VALIDATION OPINION

VALIDATION OF POST REGISTRATION CHANGES OF THE

HEBEI GUYUAN COUNTY DONGXINYING 199.5 MW WIND POWER PROJECT

REPORT NO.CHINA-PRC/8579/2012

Figure 1 Metering system diagram

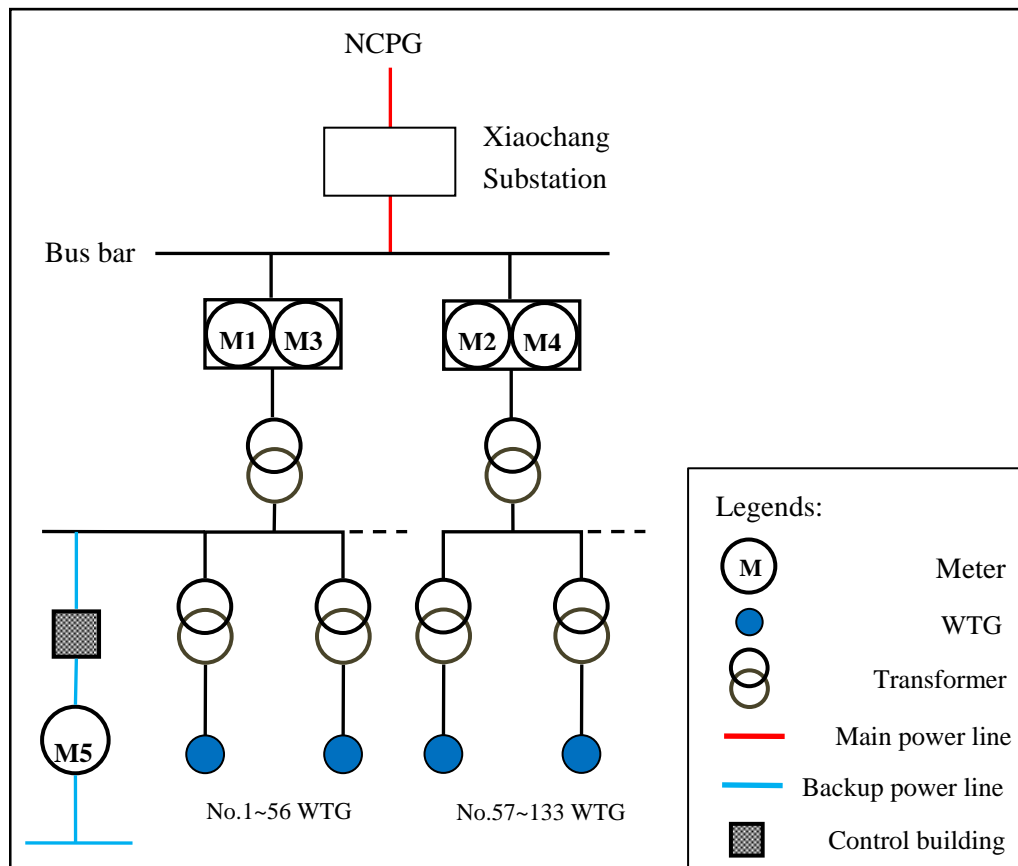
After 10/01/2012, it was noticed that actually two pairs of meters were installed on the high voltage side of the two onsite 35-220kV transformers respectively (M1 on No.1 main transformer and M3 serves as the backup meter of M1; M2 on No. 2 main transformer and M4 serves as the backup). The accuracy level of the above four meters is 0.2S. Furthermore, Meter M5 with the accuracy level of 0.5S was in place for the backup line used in emergency situation. The diagram of the metering system is shown in Figure 1.

The validation team has found that some of the provisions for monitoring the net electricity supplied by the Project are not clearly specified in the monitoring plan of the registered PDD, i.e.,

In summary, considering the actual situation, the PP realized that the monitoring plan described in the registered PDD does not reflect the actual monitoring activity of the Project. The measurement for the electricity exported and imported by two pairs of meters should be integrated into the monitoring activity of the Project and the monitoring plan has to be improved accordingly. Bureau Veritas Certification checked the reasons above as per the methodology, and has the opinion that the monitoring plan has to be improved accordingly.

The description for the current metering equipments is updated and a new diagram is provided.
